UNITED STATES PATENT AND TRADEMARK OFFICE

APPLICATION NO.	FILING DATE	FIRST NAMED INVENTOR	ATTORNEY DOCKET NO.	CONFIRMATION NO.
10/642,547	08/15/2003	Markus Hammes	L&L-10024	1990
24131	7590	10/31/2006	EXAMINER	
LERNER GREENBERG STEMER LLP			WARE, CICELY Q	
P O BOX 2480			ART UNIT	PAPER NUMBER
HOLLYWOOD, FL 33022-2480			2611

Office Action Summary	Application No. 10/642,547	Applicant(s) HAMMES ET AL.	
	Examiner Cicely Ware	Art Unit 2611

DETAILED ACTION

Fig. 1
PRIOR ART

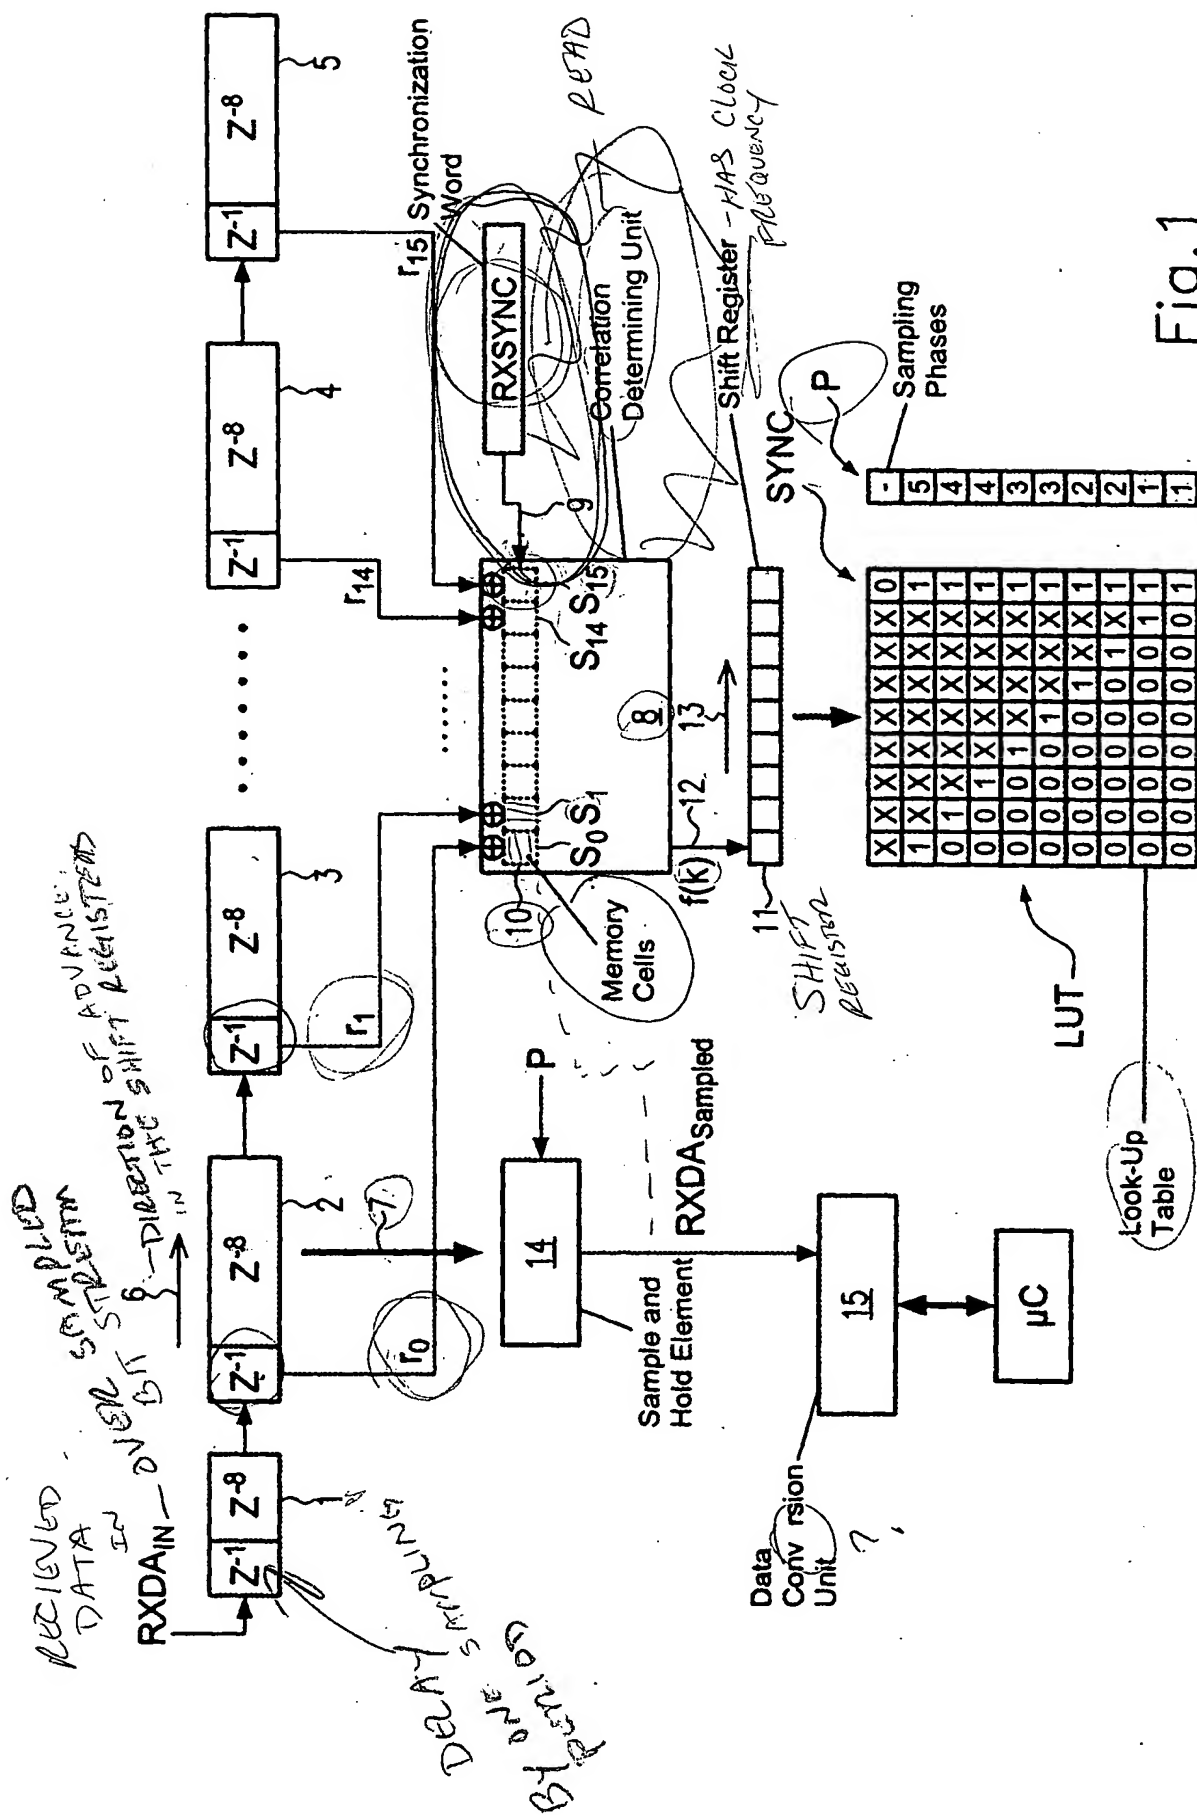
a. Fig. 1, element 15, applicant uses "Data Conv rsion Unit". Examiner suggests using "Data Conversion Unit" for clarification purposes.

(1) With regard to claim 1, Applicant's Admitted Prior Art discloses in (Fig. 1) an apparatus for ascertaining and correcting an optimum sampling time for an oversampled digital stream in which samples are taken at n different sampling times for each bit, the apparatus comprising: a reading unit (7, 8) for reading each next digital bit stream at said optimum sampling time (Pg. 2, lines 22-26- Pg. 3, lines 1-5, Pg. 16, lines 11-25); a correlation determining unit (8) for determining a correlation between a sequence of sampled data bits and a comparative sequence (9), said correlation determining unit providing correlation values by determining an associated correlation value at each sampling time; and a unit (11) for determining a new optimum sampling time from said

correlation values; said comparative sequence (10) being a continuous bit pattern; and said bit read at said optimum sampling time being fed into said comparative sequence (10, 2).

Examiner asserts that the comparative sequence is the synchronization word of Fig. 1, because it is used by the correlation determining unit to compare with the memory cells.

Applicant's Admitted Prior Art further discloses in (Fig. 1) a comparative-sequence shift register (10) for storing said comparative sequence; said bit read at said optimum sampling time being fed into comparative-sequence shift register (8, 10).

Examiner asserts that the comparative-sequence shift register is the memory of (Fig. 1 (10), because it stores the synchronization word which is the comparative sequence.

Applicant's Admitted Prior Art further discloses in (Fig. 1) a sequence of shift registers (1-5) for shifting said oversampled digital bit stream; each one of said shift registers having n register cells (Z) for holding n samples available for each bit.

Applicant's Admitted Prior Art further discloses in (Fig. 1) wherein said unit for determining said new optimum sampling time (8) determines said new optimum sampling time by considering a sampling-time range (Pg. 17, line 25 (equation discloses a range related to the hamming distance)) within which said hamming distance is below said prescribed threshold value (Pg. 17, lines 6-25).
